PERRY PLACE SUBDIVISION

Engineering Comments: FINAL PLAT COMMENTS (should be addressed prior to submitting the FINAL PLAT for review and/or signature by the City Engineer):

APPLICATION NUMBER 10 DATE July 19, 2018

DETAIL SITE PLAN

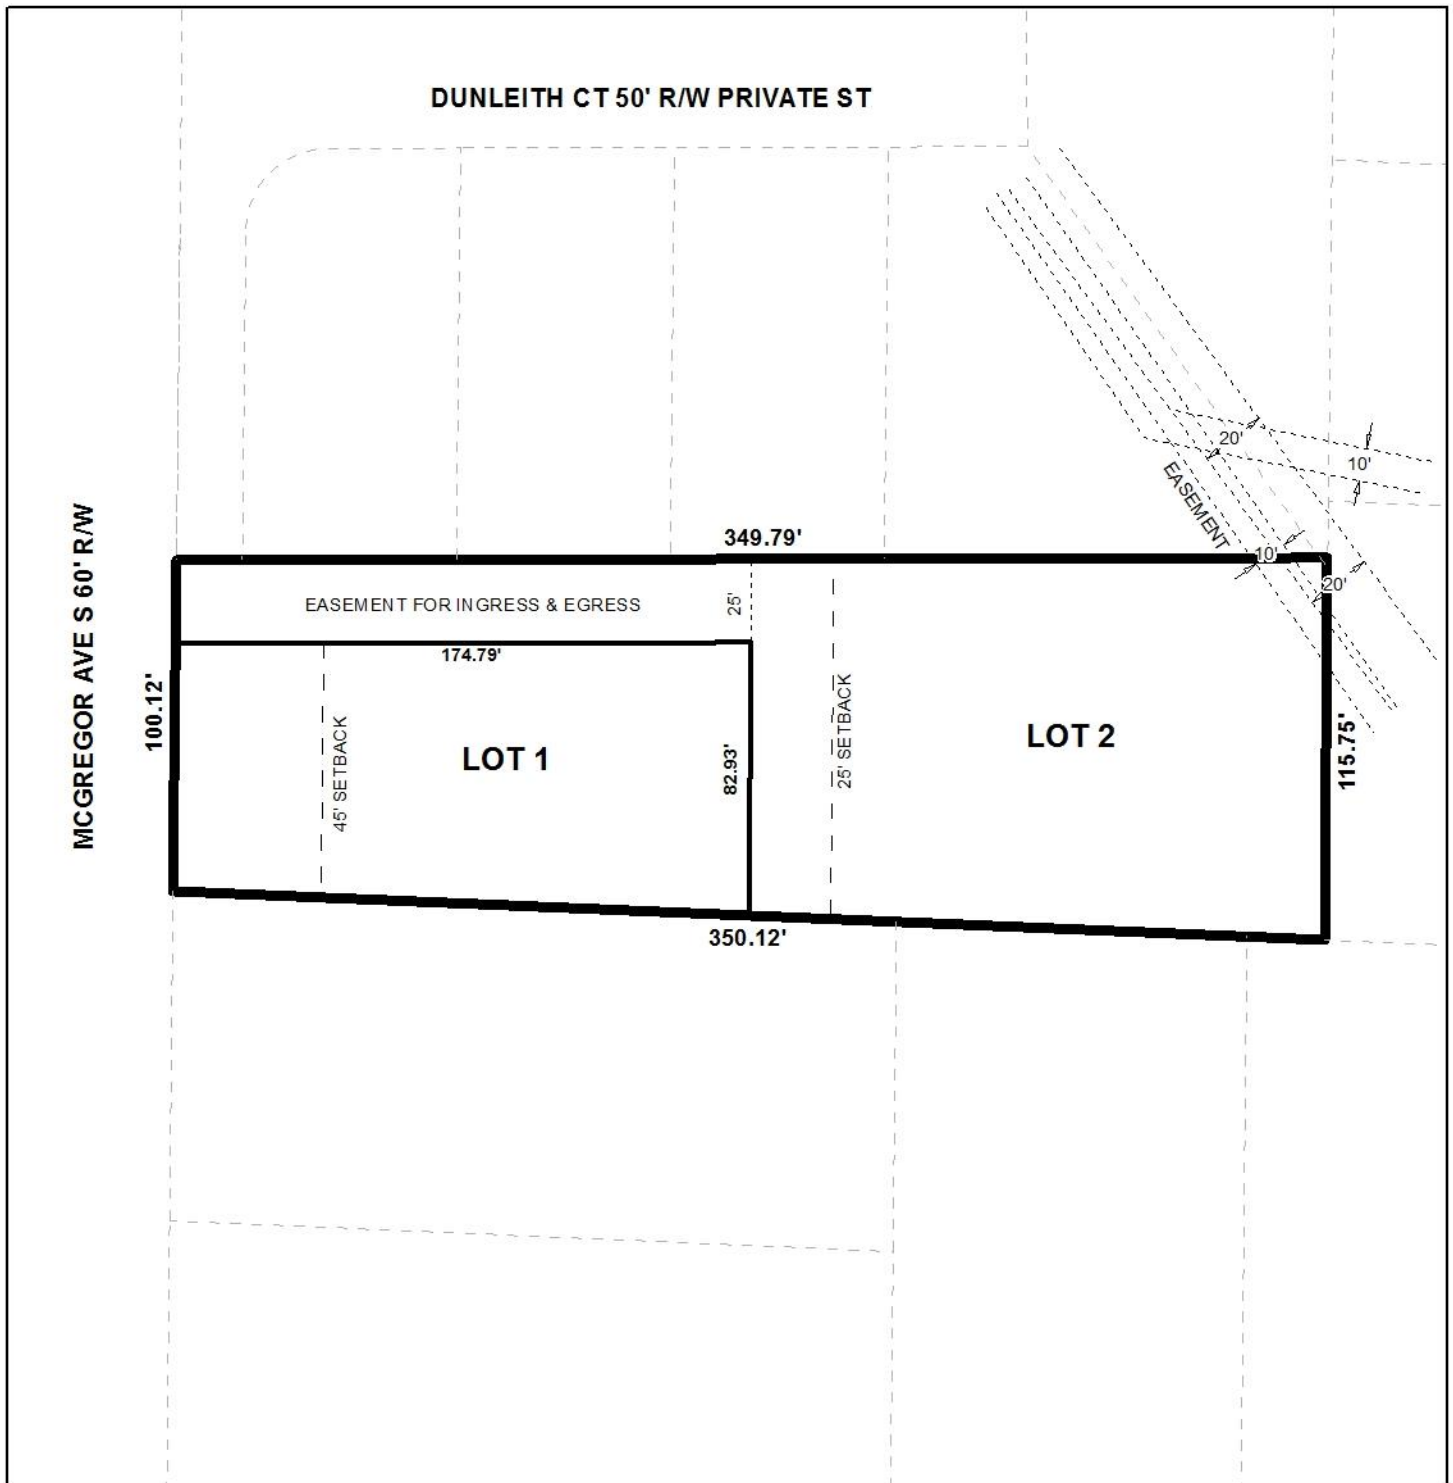
The proposed lots have frontage on South McGregor Avenue, a minor street with curb and gutter requiring a 60' right-of-way. The applicant requests a 45' minimum building setback line along

proposed Lot 1 in lieu of dedication, but the most recently adopted Major Street Plan permitted existing right-of-way along McGregor Avenue, north of Dauphin Street. As such, sufficient right-of-way is illustrated on the preliminary plat and no additional dedication should be required.

As mentioned, a 45' minimum building setback line is illustrated along proposed Lot 1, thus exceeding the 25' minimum building setback line requirement of the Subdivision Regulations. As such, retention of at least a 25' minimum building setback line for both lots where they exceed 60' in width should be required on the Final Plat, if approved.

Proposed Lot 2 is irregularly shaped and may be regarded as a "panhandle" lot, a design discouraged by Section V.D.1. of the Subdivision Regulations; the exception being the approval of lots located where varied and irregularly-shaped lot designs are common, and the informality of design is consistent with other lots in the vicinity. The Planning Commission has approved a similar design for several lots within the vicinity of the subject site, therefore a waiver of Section V.D.1. may be appropriate.

The lots meet the minimum size requirements for lots served by public water and sanitary sewer systems, but are only labeled with their sizes in acres on the preliminary plat. As such, revision of the plat to provide the sizes of each lot in both square feet and acres should be required, if approved; or, provision of a table on the Final Plat providing the same information may suffice.

Regarding access management, both lots are proposed to share access via a 25' ingress/egress easement. As such, a note should be placed on the Final Plat stating Lots 1 and 2 are limited to one (1) shared curb cut, with any changes in its size, location or design to be approved by Traffic Engineering and conform to AASHTO standards.

In addition to the 25' ingress/egress easement, a 10' sewer easement is illustrated on the Northeast corner of Lot 2. As such, a note should be placed on the Final Plat stating no structures shall be constructed in any easement.

Finally, there are two accessory structures on the site in addition to a dwelling on the proposed Lot 1. The proposed subdivision will result in one (1) of the structures straddling the lot line and the other structure to be on a lot by itself, without a primary dwelling, within the 25' minimum building setback. As such, both structures should be removed from the site, with appropriate permits, prior to the signing of the Final Plat.

- 1) revision of the plat to provide the size of each lot in both square feet and acres, or provision of a table on the Final Plat providing the same information;
- 2) retention of at least a 25' minimum building setback line along both lots where they are at least 60' wide;
- 3) placement of a note on the Final Plat stating Lots 1 and 2 are limited to one (1) shared curb cut, with any changes in its size, location or design to be approved by Traffic Engineering and conform to AASHTO standards;

- 4) placement of a note on the Final Plat stating no structures shall be constructed in any easement;
- 5) retention of the lot and common area sizes in both square feet and acres on the Final Plat, or provision of a table on the Final Plat with the same information;

- 6) demolition of the accessory structures on the site, with appropriate permits, prior to the signing of the Final Plat;
- 7) compliance with Engineering comments: (FINAL PLAT COMMENTS *(should be addressed prior to submitting the FINAL PLAT for review and/or signature by the City Engineer):* A) *Provide all of the required information on the SUBDIVISION PLAT (i.e. signature blocks, signatures, certification statements, written legal description, required notes, legend, scale, bearings and distances) that is required by the current Alabama State Board of Licensure for Professional Engineers and Land Surveyors.* B) *Review the written legal description and bearing and distance labels for discrepancies.* C) *Review the Surveyor's Certificate and provides the correct land owner's name.* D) *Provide and label the monument set or found at each subdivision corner.* E) *Provide the Surveyor's, Owner's (notarized), Planning Commission, and Traffic Engineering signatures.* F) *Add a note to the SUBDIVISION PLAT stating that as LOTS 1 and 2 will not receive any historical credit of existing (1984) impervious area towards stormwater detention requirement per Mobile City Code, Chapter 17, Storm Water Management and Flood Control).* Each LOT must submit a TIER 2 Land Disturbance Permit and include stormwater detention. G) *Add a note to the SUBDIVISION PLAT stating that a Land Disturbance permit will be required for any land disturbing activity in accordance with Mobile City Code, Chapter 17, Storm Water Management and Flood Control); the City of Mobile, Alabama Flood Plain Management Plan (1984); and, the Rules For Erosion and Sedimentation Control and Storm Water Runoff Control.* H) *Add a note to the Plat stating that the approval of all applicable federal, state, and local agencies (including all storm water runoff, wetland and floodplain requirements) will be required prior to the issuance of a Land Disturbance permit.* I) *Add a note that sidewalk is required to be constructed, and/or repaired, along the frontage of each lot, or parcel, at time of new development or construction, unless a sidewalk waiver is approved.* J) *Add a note to the plat stating that all proposed detention facilities, common areas, and wetlands shall be the responsibility of the Property Owner(s), and not the responsibility of the City of Mobile.* K) *Add a note to the plat stating that all easements shall remain in effect until vacated through the proper Vacation process.* L) *Provide a copy of the FINAL SUBDIVISION PLAT to the Engineering Dept. for review. No signatures are required on this drawing.* M) *After addressing all of the FINAL SUBDIVISION PLAT review comments by the Engineering Dept. provide the red-line markup, the ORIGINAL (with all other signatures) and one (1) copy of the revised original (signatures not required) of the revised Final Plat to the Engineering Department.);*
